VILLAGE BOARD AGENDA
Wednesday, July 8, 2026 at 7:00 PM

1. Plan Commission Recommendations 6.24.26

To: Village of Mount Horeb Plan Commission
From: Village Planner: Ben Rohr, AICP
Date: June 24, 2026
Re: Specific Implementation Plan (SIP) and Design Review for 21 Proposed Single-Family Homes at the Southern End of Brookview Trail for Brookstone South, LLC.

LEFT ELEVATION

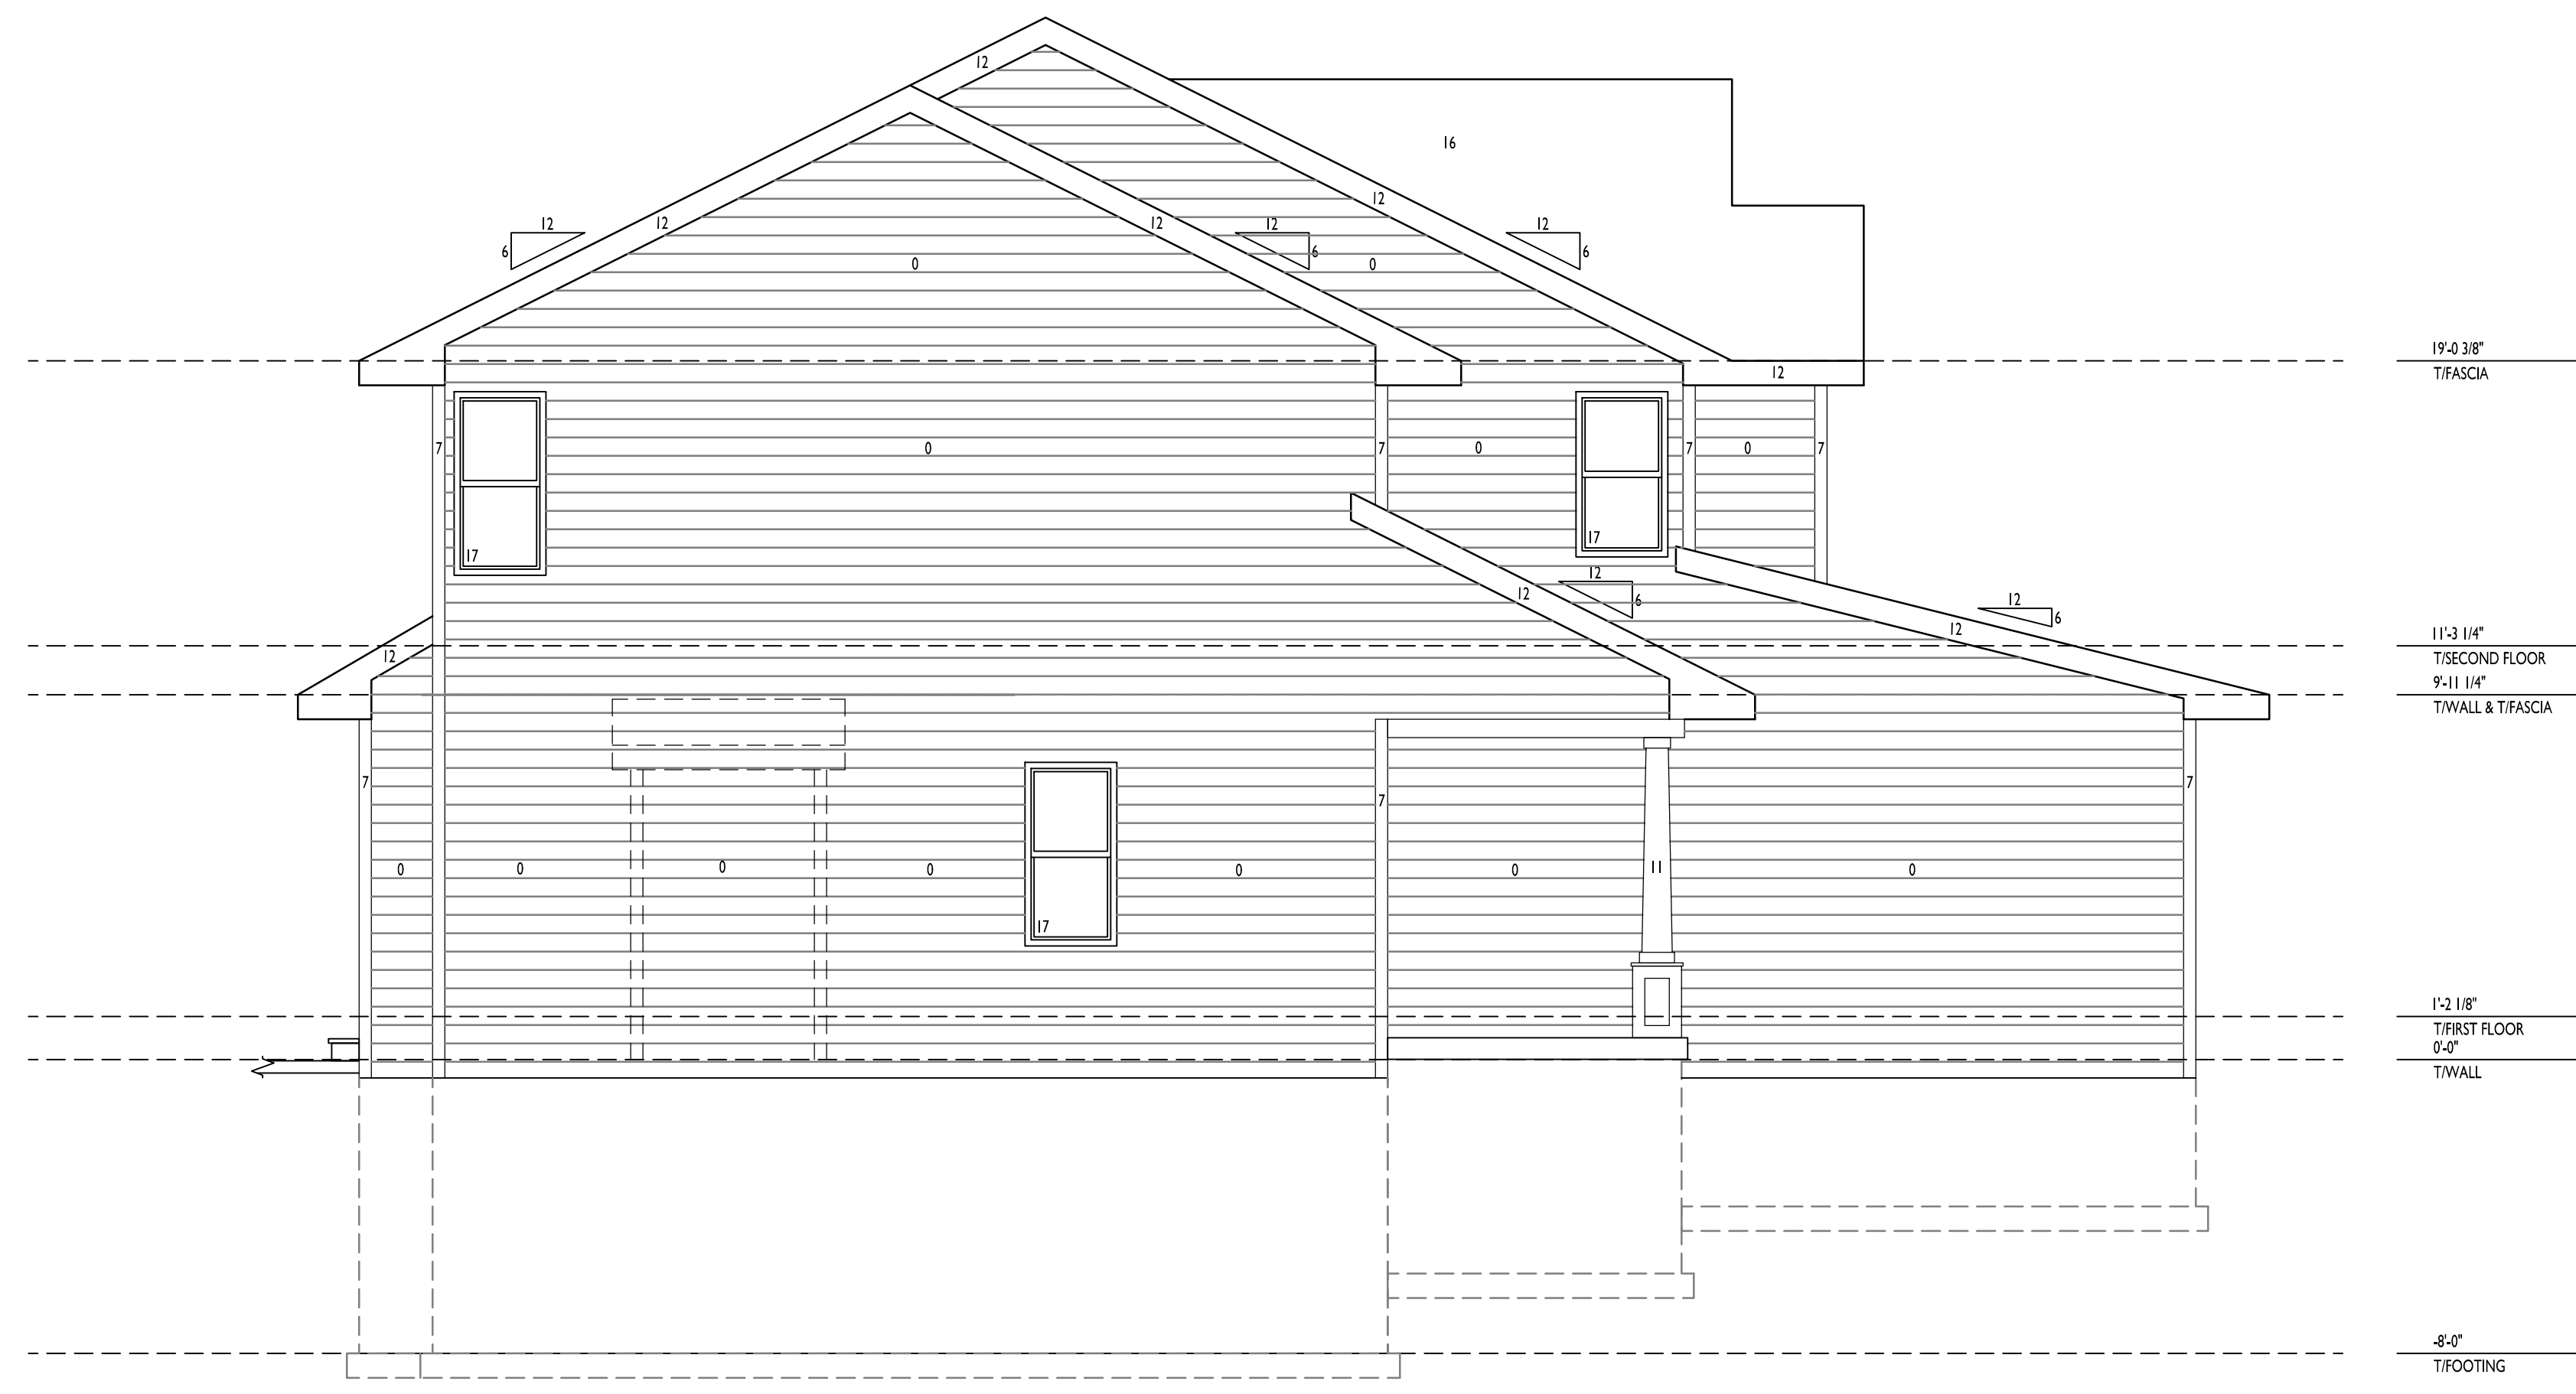
- a. Long building facades shall be visually broken up and variegated with staggers and offsets as determined appropriate by the Plan Commission.
 - This requirement is met on the front and rear elevations of each unit through varying roof pitches, windows, and doors. This requirement is not met along the side facades of each structure where very little articulation is proposed. Because each unit will be 12 feet apart, limited widow openings are necessary to provide privacy between the units. Additionally, this project is more in line with a single-family neighborhood where there are often longer building facades without articulation. I recommend the Plan Commission waive this requirement for the side facades for these reasons.

- This requirement may be met. The prominence of the front-loaded garage was discussed during the GDP and concept review meetings for this project. I recommend the Plan Commission discuss this requirement again.

- This requirement may be met. The prominence of the front-loaded garage was discussed during the GDP and concept review meetings for this project. I recommend the Plan Commission discuss this requirement again.

- This requirement is not met. No architectural base feature is included within any proposed unit type. I recommend that the Plan Commission discuss this item further.

5. Plan Commission Action on (related to requirement 7.b. and c.):
 - a. Requiring resubmittal with an alternative front façade design that further reduces the prominence of the front-loaded garages to include:

6. Plan Commission Action on (related to requirement 8.b.):
 - a. Requiring resubmittal with an alternative front façade design that includes a 40" hard durable base material to include:
